REMARKS

By this Amendment the specification has been amended to improve its presentation, claim 1 has been amended to include the feature of claim 2 (now canceled), to include the feature discussed in the specification on page 4, lines 11-13, and to address the examiner's formality rejection under 35 U.S.C. 112, and claims 3 and 4 have been amended to better depend from amended claim 1. Entry is requested.

Fig. 3

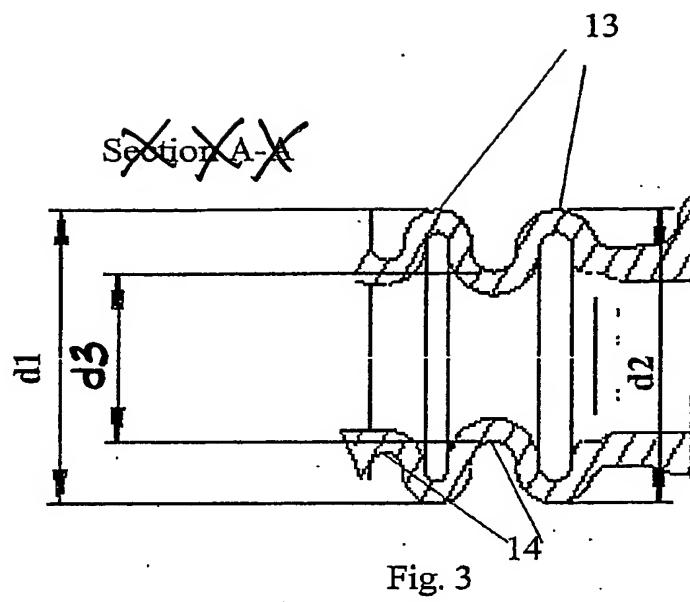
In the outstanding Office Action the examiner has objected to the disclosure because the statement on page 3, lines 25-27, appears inconsistent with the brief description of the drawings wherein Fig. 3 (sectional view) and Fig. 4 (side view) are both labeled as corresponding to Fig. 2.

Actually, both the drawings and the specification are correct. Fig. 3 is a cross-section of Fig. 4, and the tube in Fig. 2 has an oval cross-section, such that perpendicular views should vary!
